FIELD ENGINEERING BULLETINREF. NO. 60829
MODEL BD-8206-04
ATR-100
PAGE 1 OF 6
SUPERSEDES
DATE OF ISSUE 6/82

TITLE: SHUTTLE SPEED CONTROL KIT

To allow control of shuttle speed when CCIR reels are used. Also to optimize for best tape pack at highest speed.

V. PROCEDURE-continuedPIGGYBACK PWA-4051086PWA-4050860

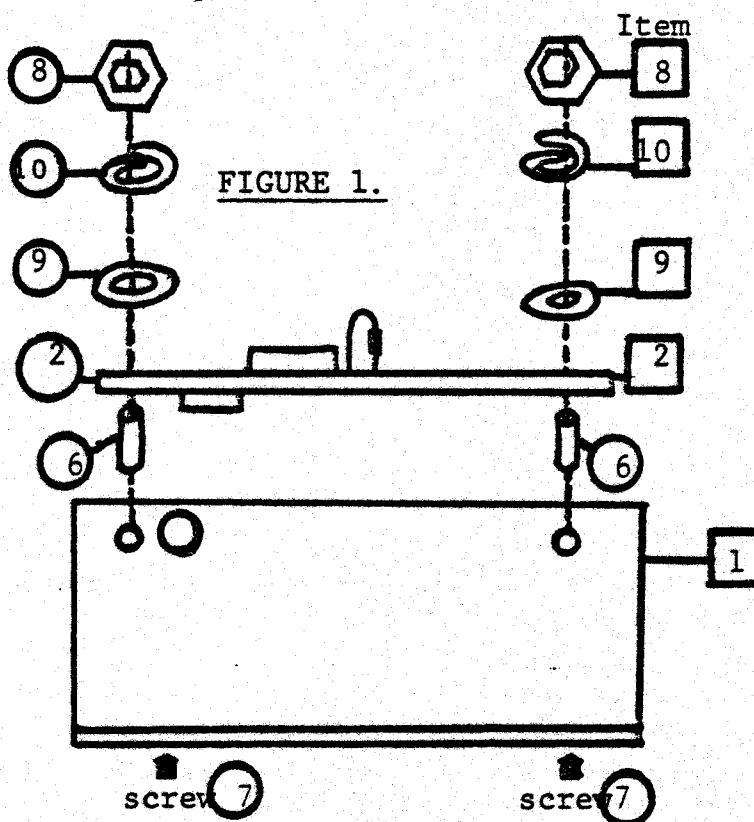
1. Install a piggyback PWA (4051085) on the new shield assembly (4120029-AC) as shown in Figure 1.
2. Remove the old shield assembly and install the new one.
3. Connect wires as shown below:
(Older PWA's may require the removal of R38 and the holes relabeled E12 and E13 as shown in Figure 2.).

4. This completes the installation of the kit.

Remove old Shield Assembly and install new assembly.

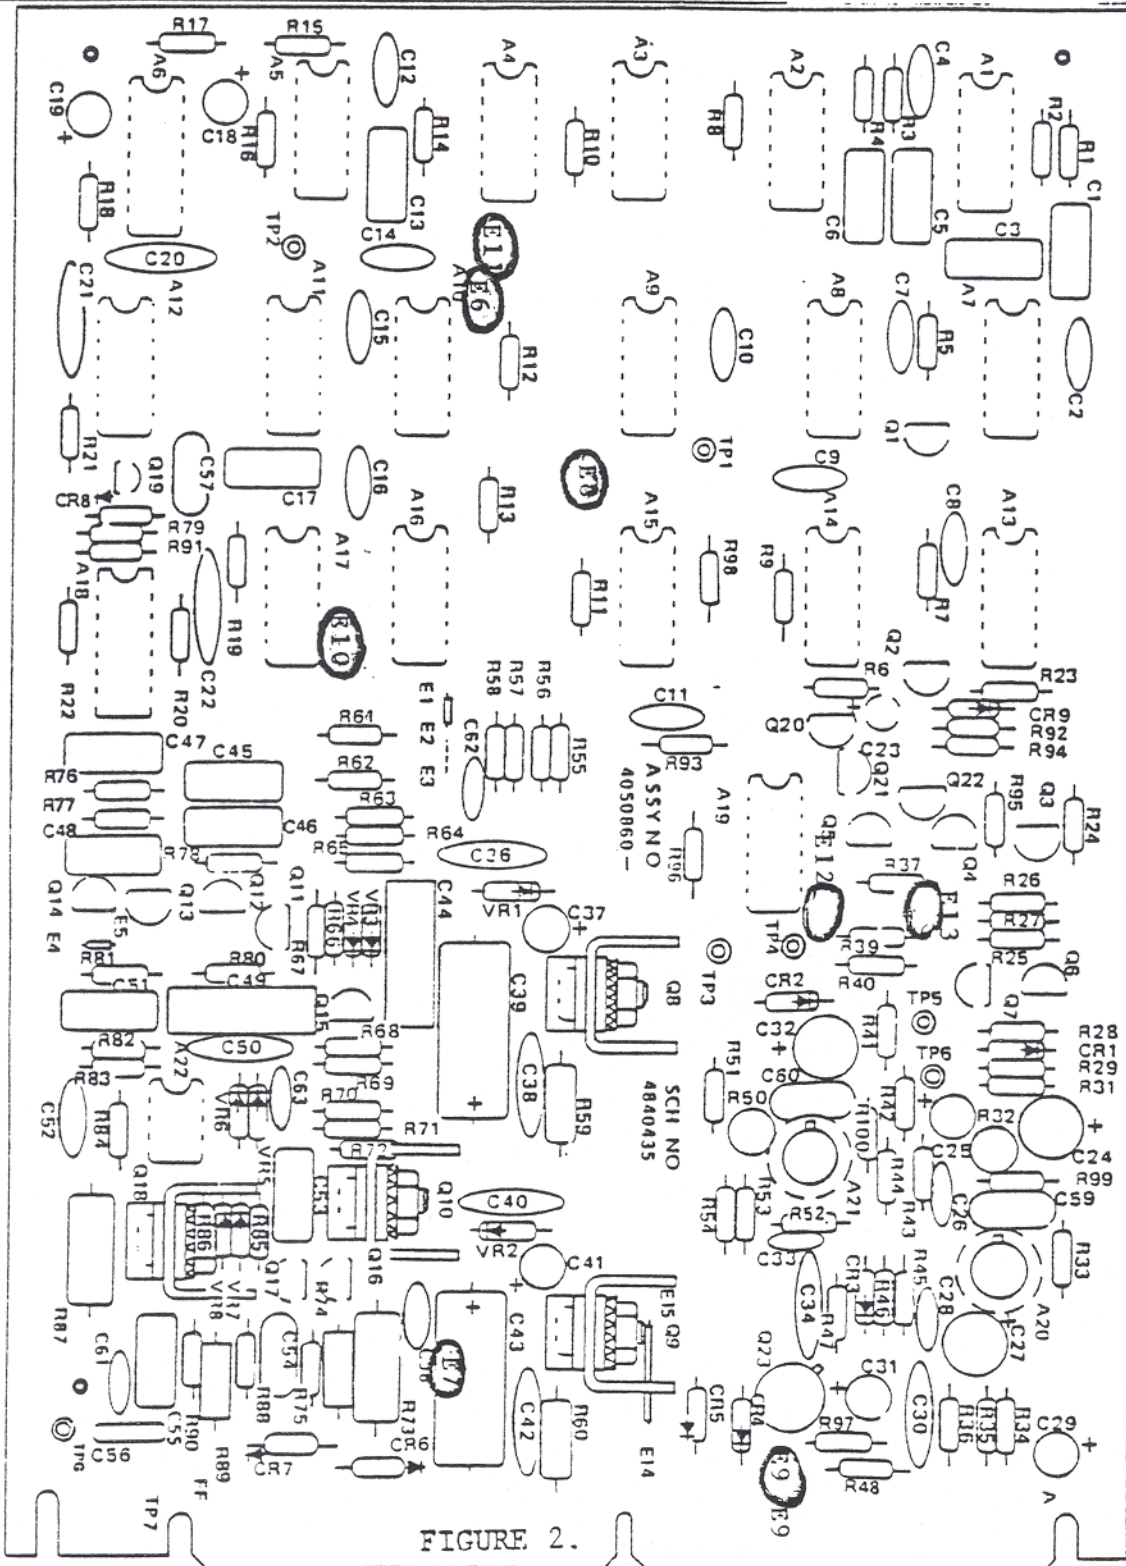
R38 (on some PWA's) should be removed and holes labeled E12 and E13 as per drawing 4050860.
